Department of Planning & Community & Economic Development  
**Planning Division**

Date: July 21, 2010

Subject: Planning Division Staff Recommended Changes to the Draft Mid-Town Neighborhood Plan Amendment

**Map 6:  
Pedestrian-Bicycle  
Facilities**

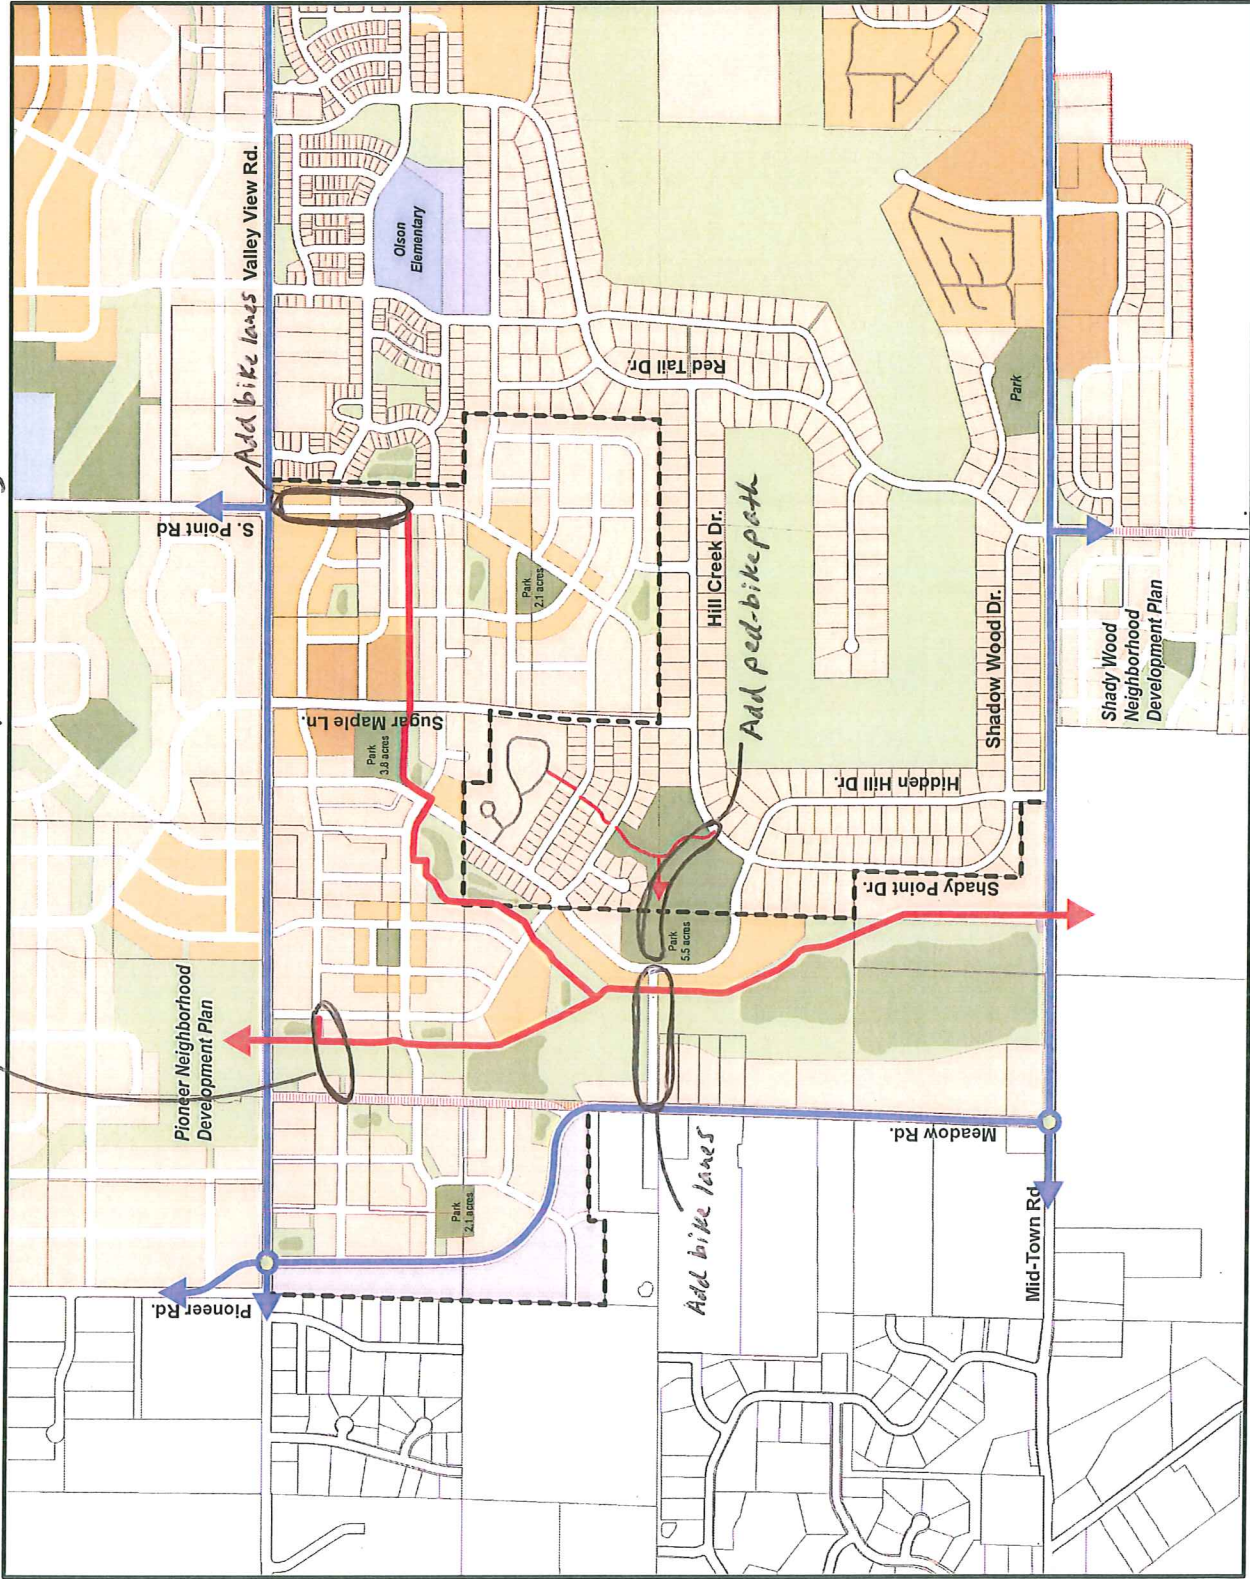
1. Show another crossing of the Lower Badger Mill Creek (LBMC) corridor at the first east-west street south of Valley View Road. Amend the text to note that if a street crossing is not feasible then a pedestrian-bicycle path should be provided. Staff considers the two LBMC crossings currently shown on the draft Plan Amendment maps to be higher priority street crossings than this third proposed street crossing.
2. Add bicycle lanes to the portion of South Point Road between Valley View Road and the east-west pedestrian-bicycle path.
3. Add bicycle lanes to the planned street between Meadow Road and Hill Creek Park.
4. Add an east-west pedestrian-bicycle path through Hill Creek Park between the street that terminates into the Park and Hill Creek Drive. The path should have the typical width of 10 feet.

Add street or at least ped-bike crossing
